City of Pomona Historic Preservation Commission

FILE NO: MAJCOA-000360-2025

A request for a Major Certificate of Appropriateness (MAJCOA-000360-2025) to legalize twenty-four (24) unpermitted vinyl windows on the primary structure of a contributing resource within the Hacienda Park Historic District.

ADDRESS: 1515 GANESHA PLACE (APN: 8359-018-023)

Drawing title
SFD FLOOR PLAN /
WINDOWS
SCHEDULES

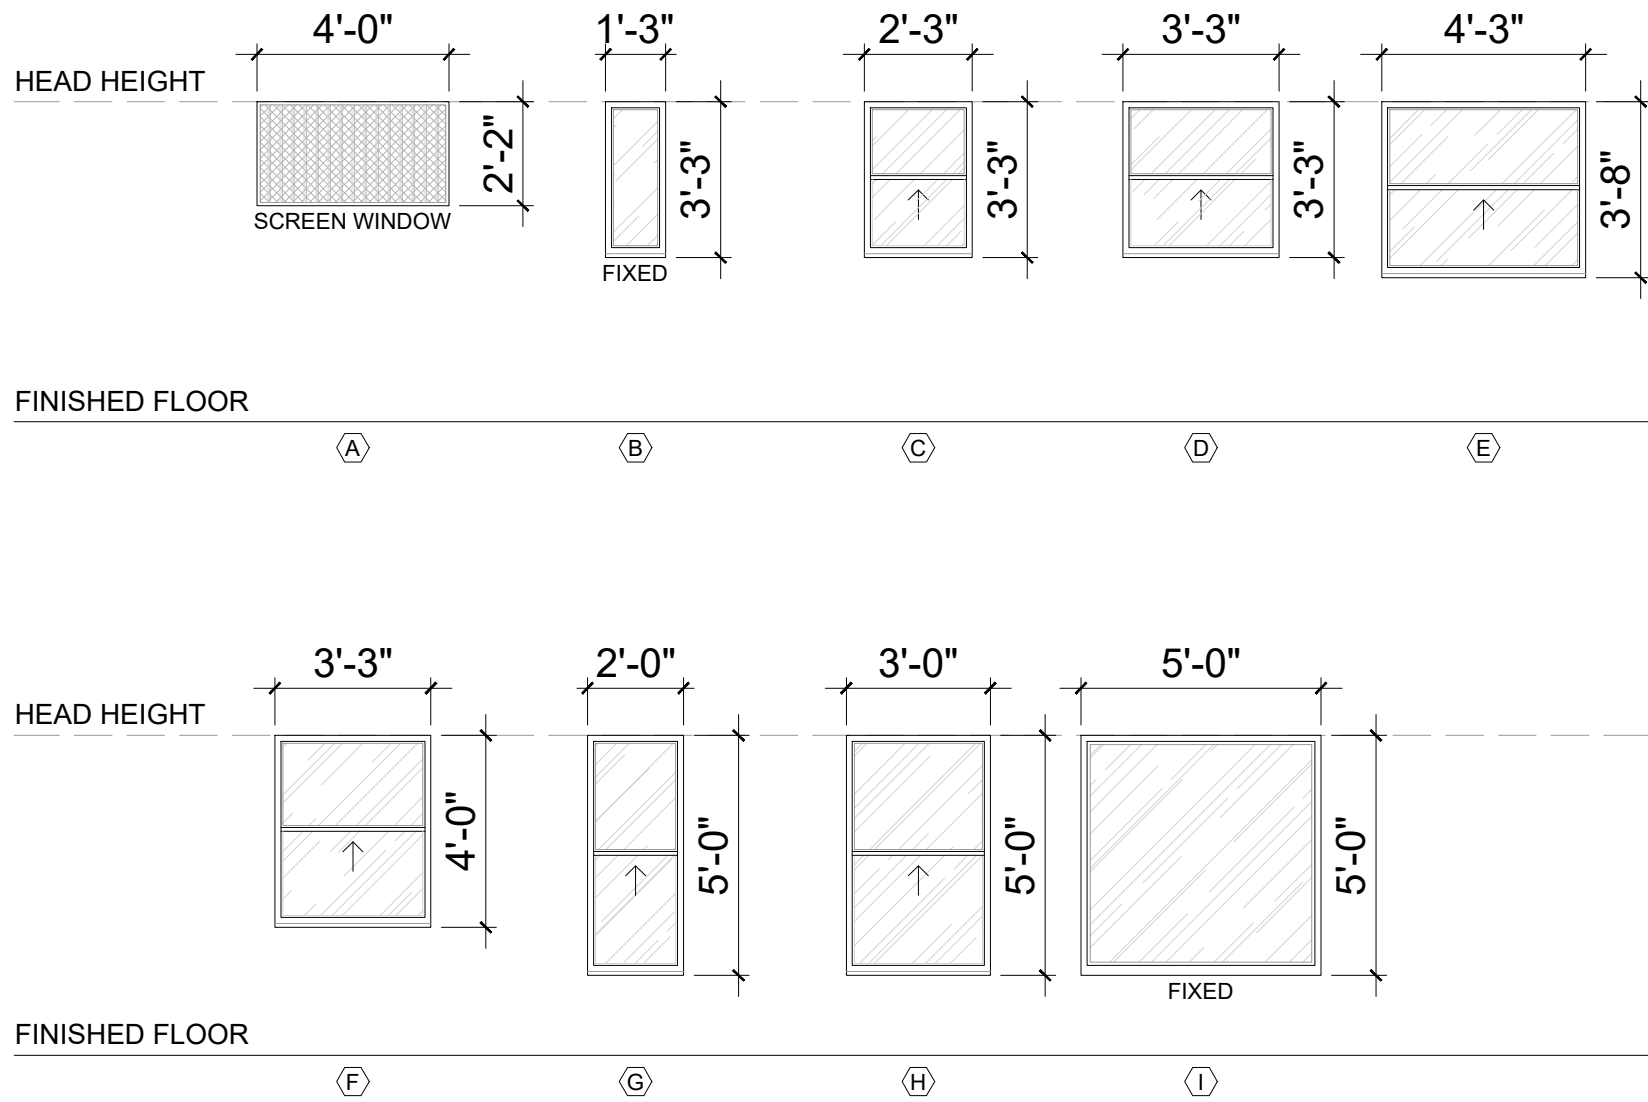
The existing windows, estimated to have been replaced in 2014, are also hung windows but are vinyl in material. These windows are of the same dimensions as the original windows however vinyl is not a material that is compatible with the period or style.

Though the windows retain their original sizes and opening styles (single-hung) the material is not compatible with the period or style of the home or neighborhood.

NOTE:
WINDOW MATERIAL: VINYL
